VISION STATEMENT

**CITY OF WACONIA
JUNE 2ND, 2022**

Meeting Date:		July 7, 2022				
Item Name:		SITE PLAN & DESIGN REVIEW - Darabi Dermatology - submitted by Stephen Paetzel, Mohagen Hansen Architectural Group				
Originating Department:		Community Development				
Presented by:		Ethan Nelson				
Previous Council Action (if any):		Planning Commission recommendation of approval for Site Plan and Design Review for Darabi Dermatology via a 4-0 vote.				
Item Type (X only one):	Consent		Regular Session	X	Discussion Session

Meeting Date:		July 7, 2022				
Item Name:		PUBLIC HEARING – Woodland Creek 5 th Addition Preliminary Plat and				
Originating Department:		Community Development				
Presented by:		Ethan Nelson				
Previous Council Action (if any):		Planning Commission tabled the Preliminary Plat and Rezoning Request during the May 5th, 2022, regular session.				
Item Type (X only one):	Consent		Regular Session	X	Discussion Session

UTILITY PLAN

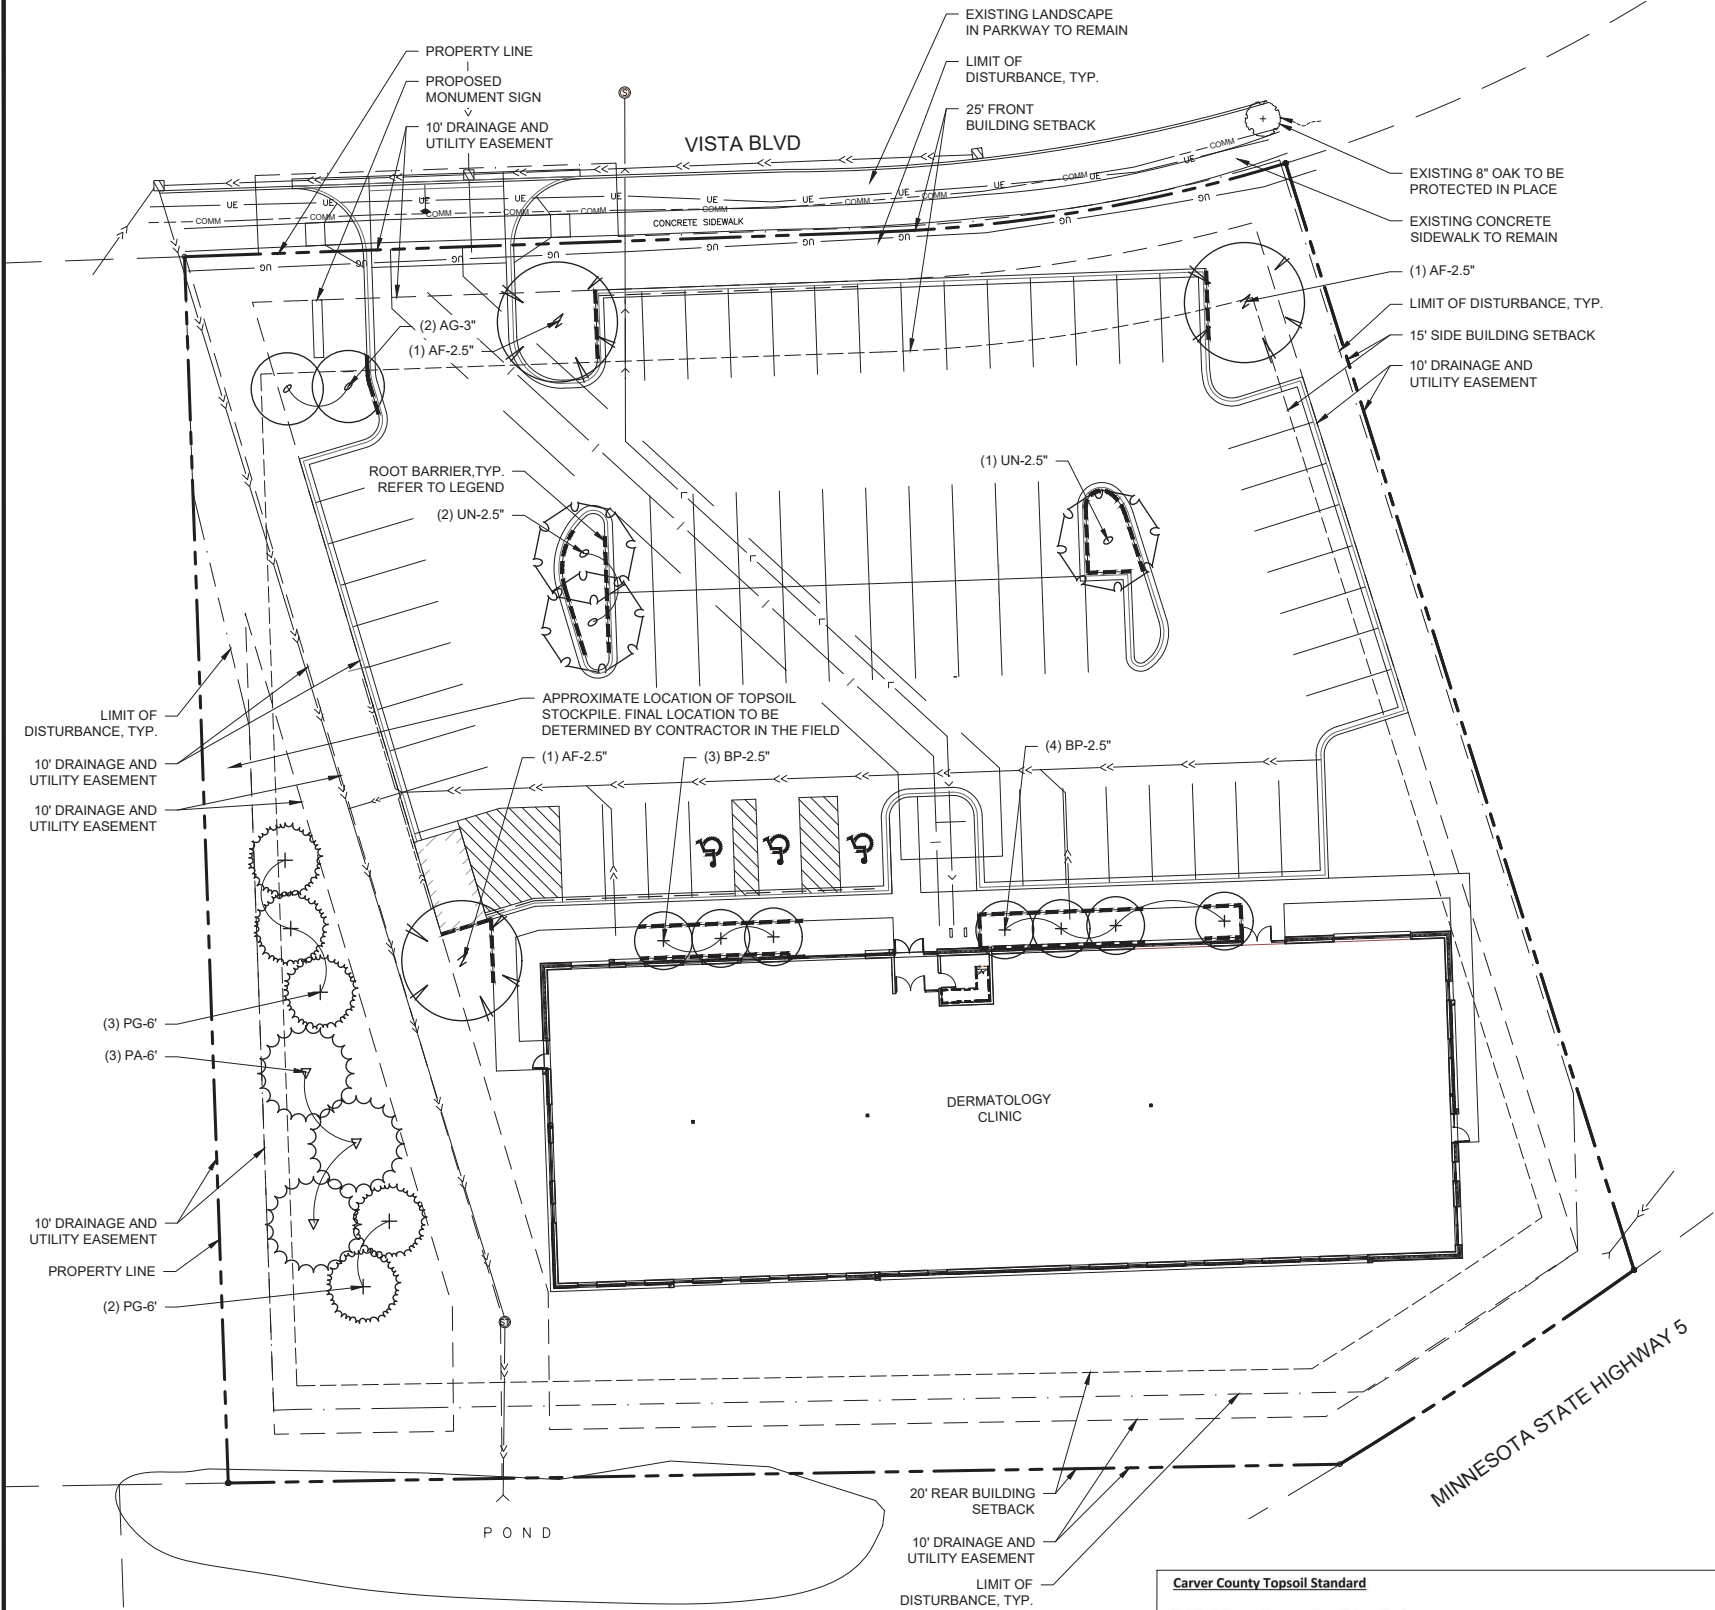
3. Work within public right-of-way and connections to watermain must be coordinated with the Waconia Public Services Department. Contractor must provide a minimum 48-hour notice prior to any work being performed.
